Melton Planning Scheme Amendment C146 & C147

Expert Witness report provided to Planning Panels Victoria

Drainage Evidence (Property 67 and 68)

Prepared for ID Taylors Road Pty Ltd

**Figure 4: Recommended waterway corridor (Option 2)**

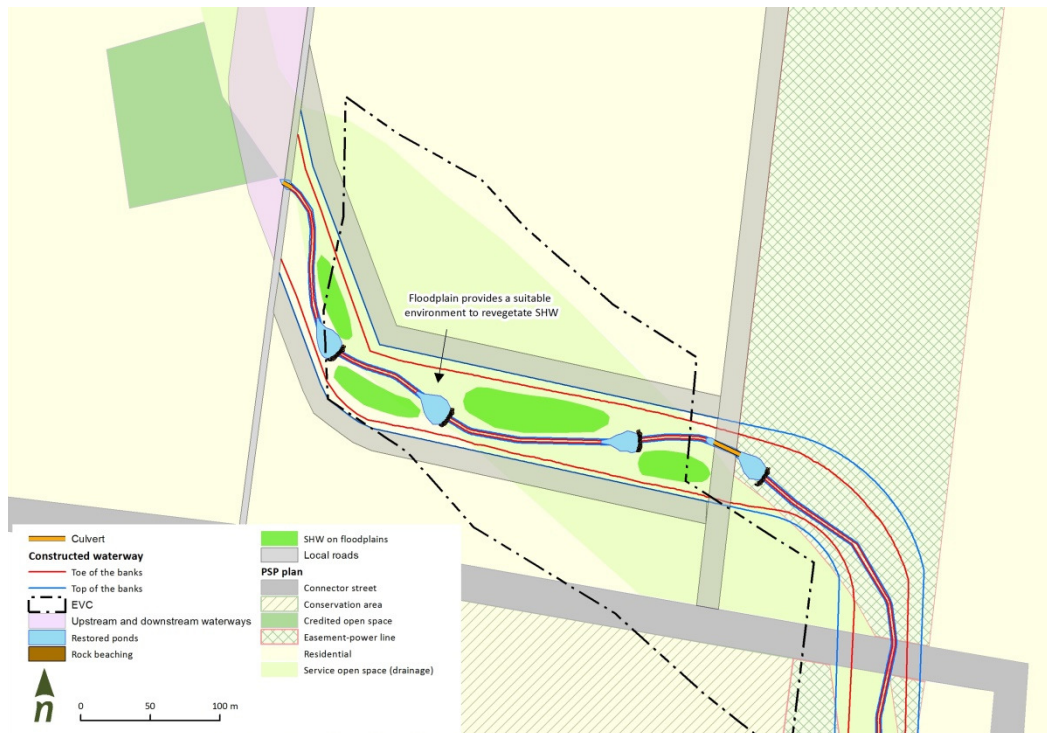
I believe that Option 2 for the waterway corridor through property 67 should be adopted and the PSP amended accordingly. Option 2 provides a feasible and sustainable system to re-create geomorphology and vegetation values associated with the region (refer to Figure 4).

Melbourne Water has considered and reviewed the recommended waterway corridor (Option 2) and provided their in-principle support. Refer to email extract below from James Hodgens (Melbourne Water) on the 5/9/16:

*“Melbourne Water, in principle, supports Option 2 for the constructed waterway for the N11 subject to further detailed design at the development stage. Our Service Delivery team has accepted this proposal for ongoing maintenance purposes once the asset is delivered to Melbourne Water after construction. We will advise the VPA of this agreement to adjust the waterway reserve to reflect option 2 in the PSP and DS Scheme in this example.”*

Whilst the general waterway corridor is 60 metres wide, I also believe that the PSP should include the following words to clarify the transition in waterway corridor width between property 66 and 67:

*“W123: A 60 metre wide constructed waterway with restored chain of ponds and revegetated Seasonal Herbaceous Wetland benches, except for a transition section (from 45 metres to 60 metres) in the upper reach of the waterway corridor. The transition zone extends from the western title boundary of property 67 to the northern extent of the most upstream revegetated seasonal herbaceous wetland bench.”*

Figure 5: Current Melbourne Water scheme layout

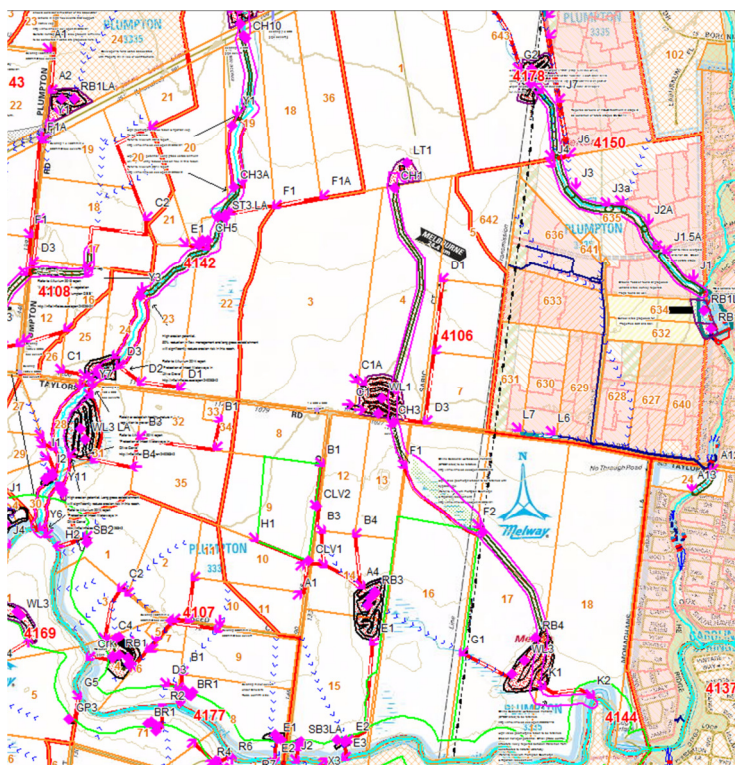
Melbourne Water's scheme includes a wetland/retarding basin (WI24 in the PSP) that straddles the 905 Taylors Road site and the adjoining downstream landholder (855 Taylors Road). Melbourne Water advised that the objective of WI24 was to treat urban development south of Taylors Road as upstream scheme wetlands were all planned to meet best practice for their respective catchments.

Based upon work undertaken by Alluvium/ID the exhibited PSP has now located the waterway corridor within the powerline easement and created a rectangular drainage reserve for the wetland/retarding basin. The latest proposed layout significantly improves:

Figure 6: Typical cross section through WI24 reserve (including retaining wall in residential allotment)

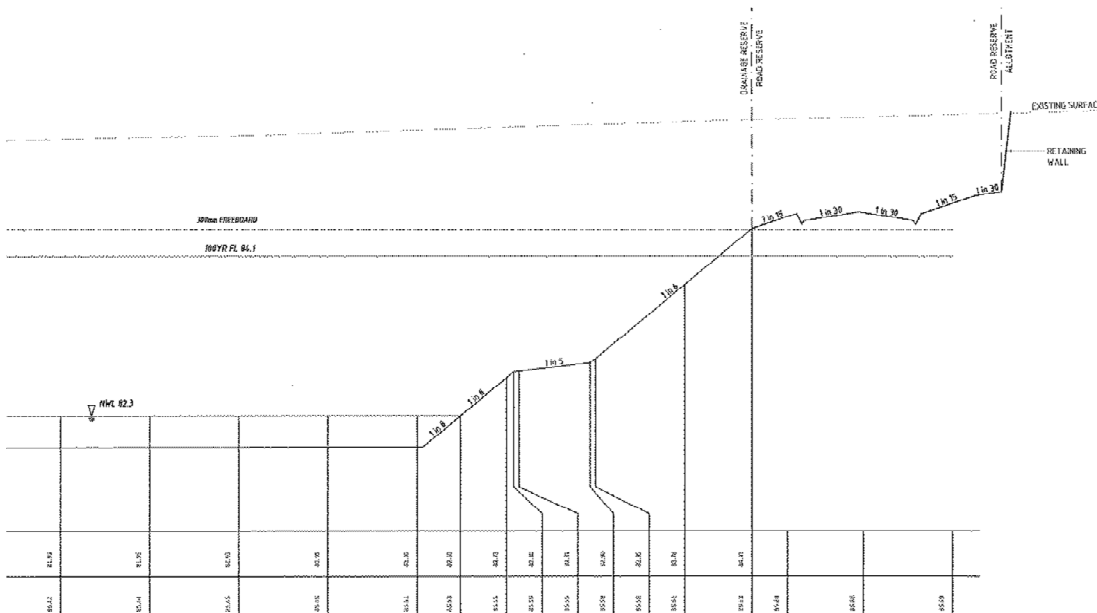
Based upon the 3-dimensional earthwork modelling undertaken for the functional design of the wetland and retarding basin, the maximum batter within the drainage reserve is 1 in 6 (which is within Melbourne Water's and Council's requirements for batter slopes). There are no retaining wall structures within the drainage reserve. However towards the western end of the reserve the adjoining road reserve and allotments have been "benched" into the existing surface to manage the surface level differentials. This includes the use of some small retaining walls (less than 1 metre) within the front of the residential allotments (refer to Figure 6). The functional design plans are included in Appendix B.

This functional design provides an urban design outcome that not only meets the water quality and quantity requirements but does so through efficient use of space. There are no retaining walls that will require Melbourne Water or Council to maintain. Where retaining walls are used, they are located at the front of the allotments and will be in the ownership of the private landowner. These retaining walls do not provide a role in the hydraulic or water quality function of the drainage reserve. In fact they are located more than 600mm above the flood level. Their value is in reducing the amount of “wasteful” batter land that would otherwise be consumed (up to 12-15 metres in width) in the PSP. The use of retaining walls (either at the front or rear of blocks) within private allotments is not uncommon and is often used in residential subdivisions to manage the slope across blocks (refer to Figure 7).

Based on the above, I believe that the PSP be amended to show the following:

- A land budget for WI24 in the order of 4.0 hectares on property 68 and 1.4 hectares on property 69.

I believe the functional design has demonstrated that the wetland and retarding basin requirements can adequately fit within the proposed WI24 drainage reserve. The use of some small retaining walls within private allotments to manage the level differential is an appropriate and sound urban design outcome.

**Figure 3.** Flood extents for different flows under existing condition

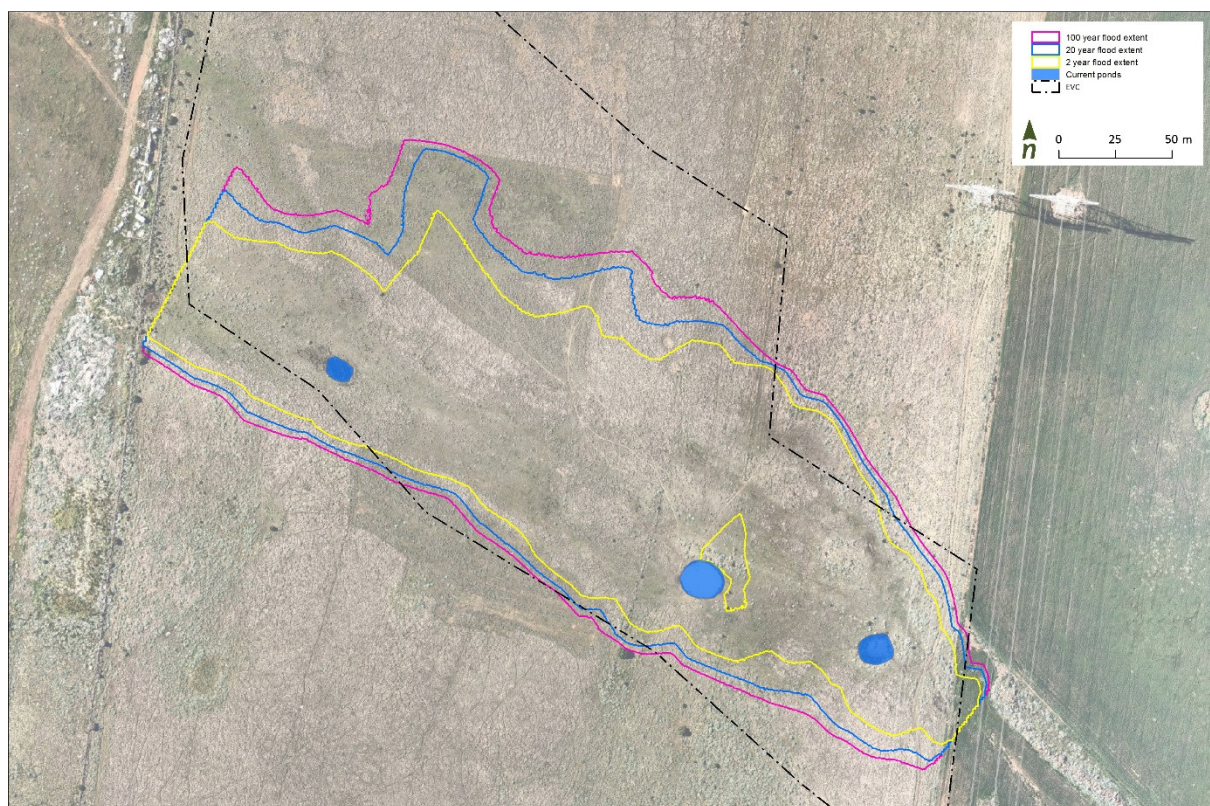
The Option 1 corridor width was determined based on the extent of the current 2-year ARI flood. This decision was made based upon the characteristics associated with the “chain of ponds” morphology, particularly their fragility to fast moving flows. That is they should be protected against regular fast moving flows. The intent of this option is for the floodplain to be retained intact for smaller flood events, which have a higher chance of occurrence, whilst for the bigger flood events the key objective is flood protection with the chain of ponds physical form being protected with rocks or similar engineering methods. Figure 3 shows different flood extents under existing conditions.

**Figure 4.** *The channel profile for option 1*

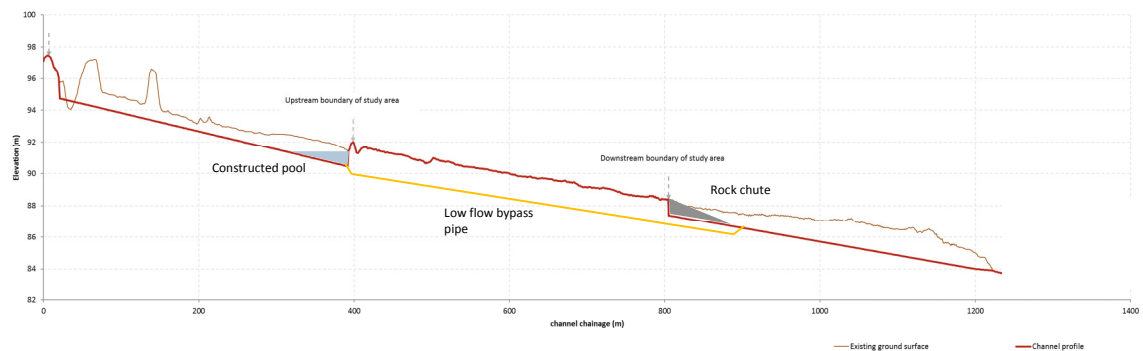
This is highlighted via a longitudinal section of the potential waterway bed (Figure 4). The Option 1 approach will require a constructed waterway upstream that is at least 2 metres below the existing invert level of the waterway. At the interface with the 961 Taylors Road property a step-up or “reverse chute/grade control” structure will be required. An upstream pond could be constructed at the interface and be used as the diversion pipe intake point. Whilst from a hydraulic and engineering function perspective an underground bypass pipeline can be constructed to take the low flows parallel to the waterway, the physical appearance of the waterway will look odd and be difficult to understand by the general community as it will appear that the waterway terminates and disappears.

The other element of this option is a rock chute at the end of the reach. The rock chute structure is required to safely transfer water from the relatively higher level intact waterway within the study area to the downstream constructed waterway which is approximately located 1 metre below the intact waterway.

**Figure 5.** The position of the Kororoit PSP road network in relation to the “chain of ponds” (Option 1)

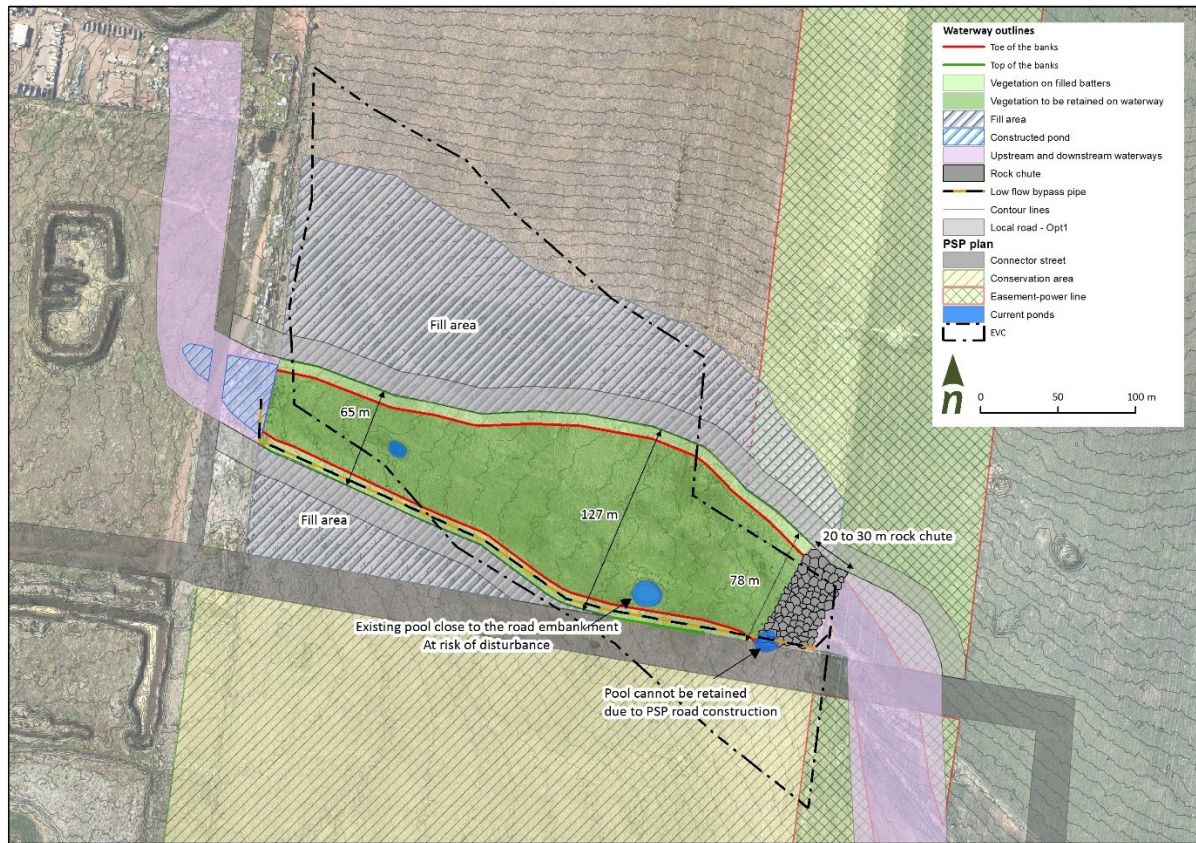
A significant constraint that threatens the feasibility for this option is the location of the proposed local roads in the Kororoit Precinct Structure Plan (PSP). Overlaying the PSP plan on the existing aerial photo shows that the geomorphic values associated with the retention of the waterway would essentially be lost as follows:

- The most downstream pool would be completely destroyed due to the east-west collector road, which goes straight through the middle of this asset
- The middle pool, which is the largest, would be significantly under threat to disturbance and loss as the future road embankment is located on the edge of the pool bank
- The upper pool is actually located outside of the waterway corridor suggested for retention in the exhibited PSP plan.

As shown on Figure 5, the implementation of Option 1 will result in significant fill being imposed upon the development of 961 Taylors Road due to the need to provide 100 year flood protection and freeboard.

Figure 8. Option 2 layout

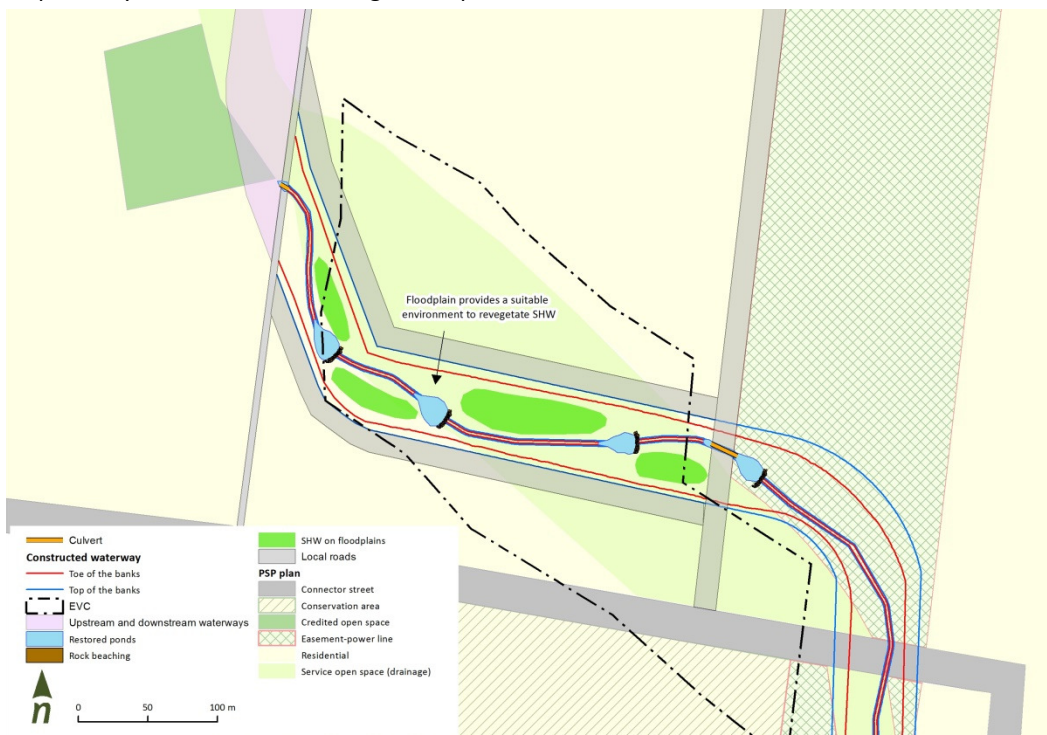
Alluvium has integrated the design principles for constructed waterways with the design criteria for SHW’s restoration to inform the layout for Option 2 (refer to Figure 8). This approach re-creates the values associated with the original land form, namely a chain of pools and seasonal herbaceous wetland vegetation. The functional design of the constructed waterway has been modelled in 12d, to demonstrate the earthworks and landforming required for this option. In summary the key design elements are as follows:

- The constructed waterway is a compound channel with a low flow channel with enough capacity to convey flow up to the 6-month ARI flows (this is consistent with the Constructed Waterway Design Manual).
- The low flow channel meanders across the base of the waterway, creating benches of varying width

- On line pools and riffles create a “choke point” in the system, which passively floods and drowns the upstream waterway and floodplain benches. The trigger point for this “passive back-flooding” is between a 3-6 month ARI

- The benches create the opportunity to support the creation of linear SHW’s. These shallow (100-200mm depth) vegetation zones are typically 10 metres wide and 40 metres long, which is similar to those created at the successful Waterways site

- The 100 year flood level and freeboard is contained within the waterway corridor and does not impose any fill on the surrounding development

Figure 9. Hydrologic regime during dry (left) and wet (right) periods

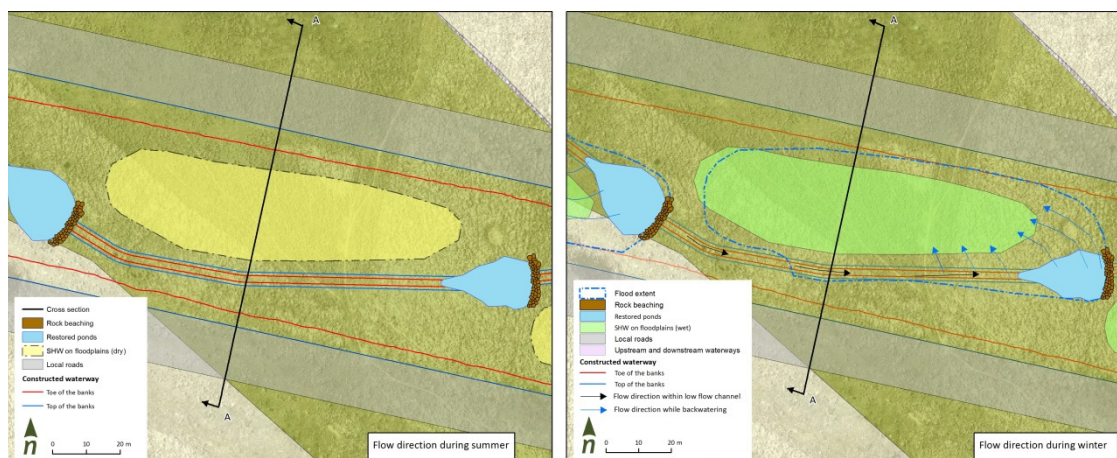
- Figure 9 shows the typical arrangement and hydrologic regime during dry times and during a wet period.
- The SHW depressions within the benches are discontinuous and the mode for water entering these areas is through downstream “drownout”. This type of functional operation will eliminate the risk of a waterway avulsion (ie the low flow channel changing course).
